**LAND USE APPLICATION COMPLETENESS REVIEW  
- Supplemental Items -**

**Subject Property:** 1105 Front Street NE

**Reference Nos.:** 24-106451-PLN (Class 3 Site Plan Review, Tentative Subdivision Plan, Class 1 & 2 Adjustment, Class 2 Driveway Approach Permit)

# The Cannery - Willamette Greenway & Compatibility Review Boundaries

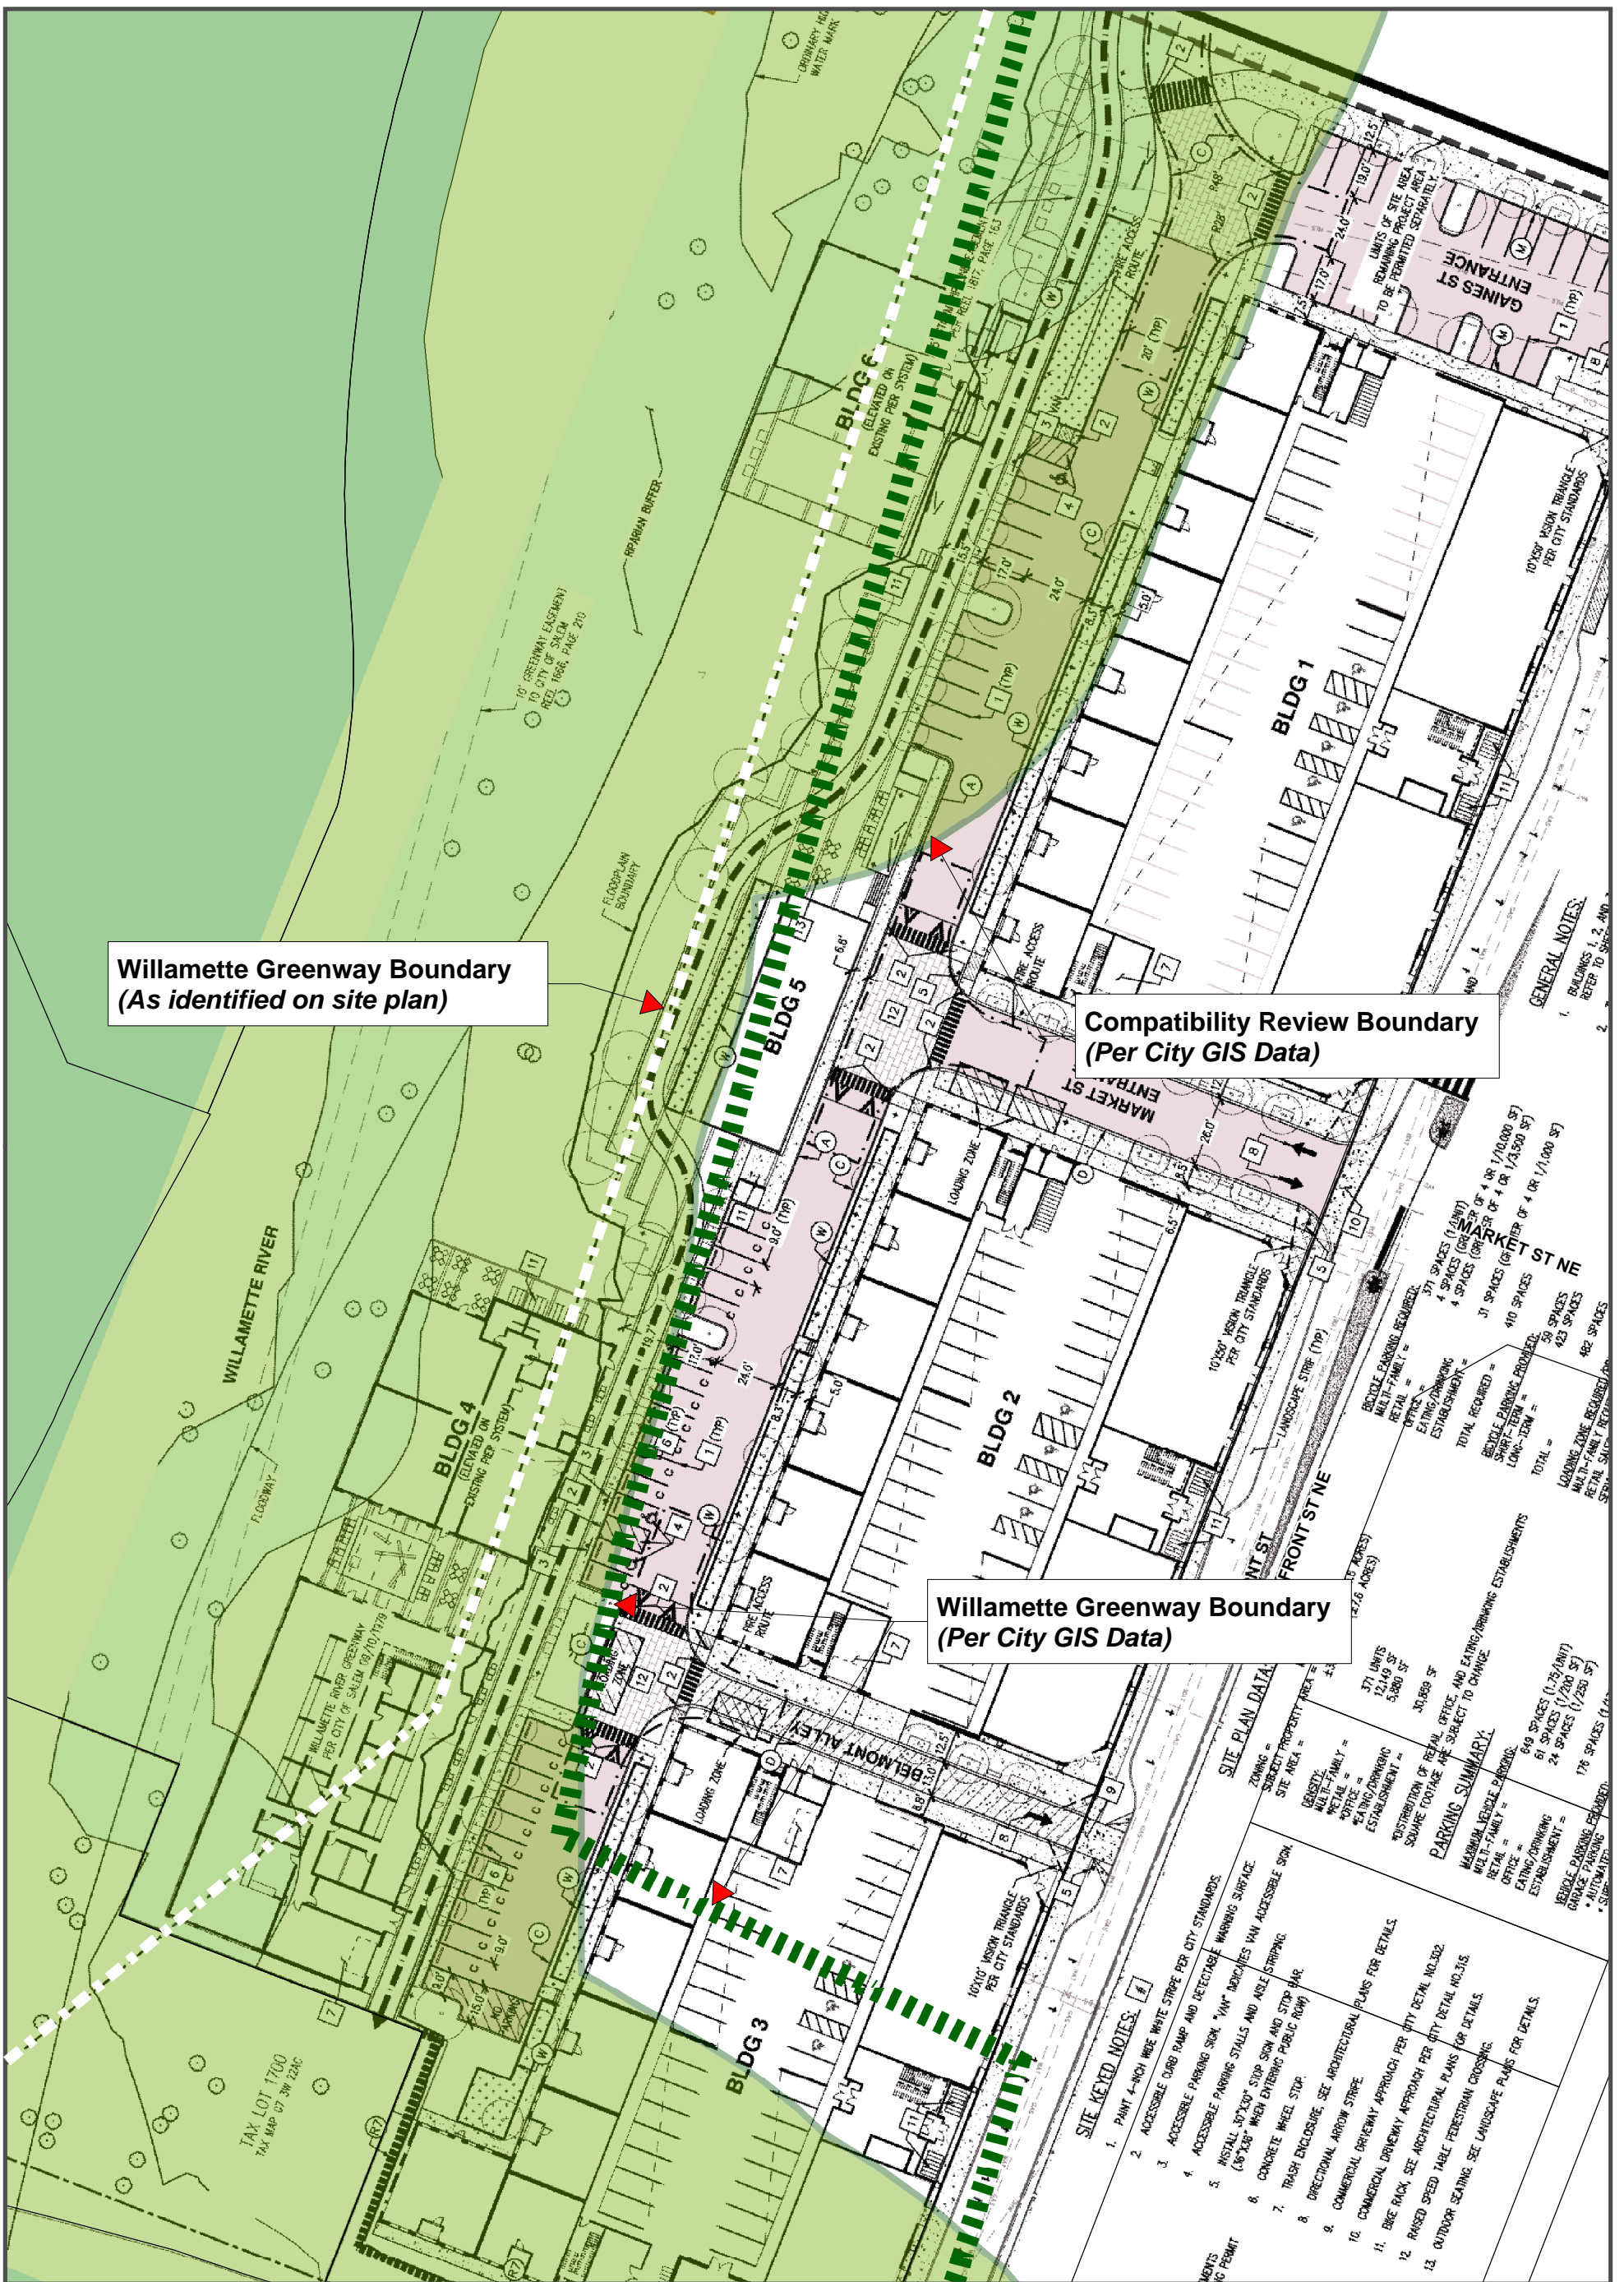
Item:	Description:
<p><b>Willamette Greenway Boundary &amp; Compatibility Review Boundary</b></p>	<p><u>Willamette Greenway Boundary:</u> The site plan submitted identifies the boundary of the Willamette River Greenway as of September 10, 1979. However, in comparison of the location of the Greenway Boundary identified on the site plan to that of City records it appears the location of the two boundary lines are different. Please see the attached site plan with an indication of the location of the Willamette Greenway Boundary per City data. The location of the Willamette Greenway Boundary on the site plan needs to be revised to show the correct location.</p> <p><u>Compatibility Review Boundary:</u> The site plan submitted identifies the Willamette Greenway Boundary but it does not show the Willamette Greenway Compatibility Review Boundary. The site plan needs to be revised to also show the Compatibility Review Boundary.</p>
